This is a letter of objection to the planning application referenced 2018/0483/P for change of use from A1 to A3 on the ground floor premises located at [100-102 Judd Street](#), WC1. This objection is written in our capacity as owners of Flat 40 Jessel House which is situated in the mansion block above the premises referred to above.

Planning Application - 2018/0483/P - 100-102 JUDD STREET—Objection

Microphone taped to tree, not "mounted on a tripod" as stated in noise impact assessment.

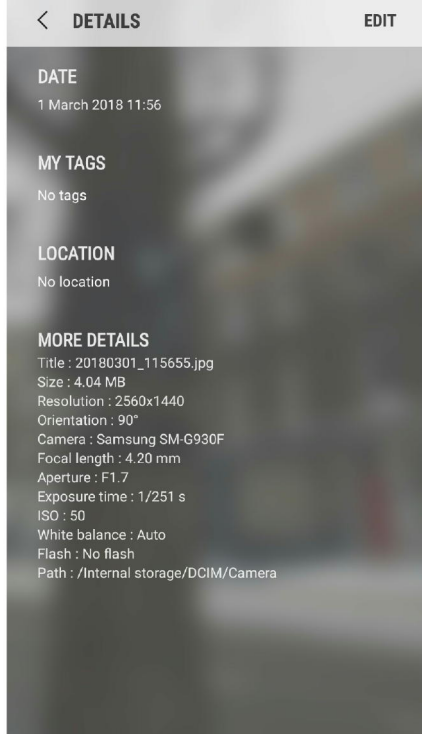
However, the attached photographs show the microphone was taped to a tree some distance from the premises and not "mounted on a tripod" .

Extractor at Humaira Restaurant vented correctly above roof line, motor housing stood away from the building.

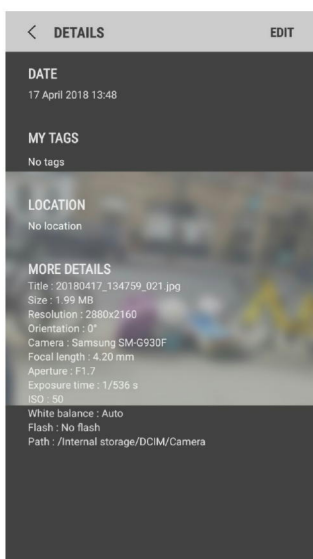
The noise impact assessment makes no mention of the construction of the residential properties being peculiarly transparent to noise having no Building Regs Part E compliance as the building was built in 1914. The installation of a fan motor housing directly beneath the living rooms of residential properties to operate 7 days per week is unsuitable in this location. I understand from neighbours who have been here longer than myself that the fan motor housing at the Indian restaurant "Humaira" at 110 Judd Street was specifically placed on the exterior of the building and placed on brackets away from the structure to mitigate noise and vibration travelling through the building.

Extract motor at Humaira Restaurant 110 Judd Street, motor is mounted on outside of building and stood away from the wall to limit noise and vibration.
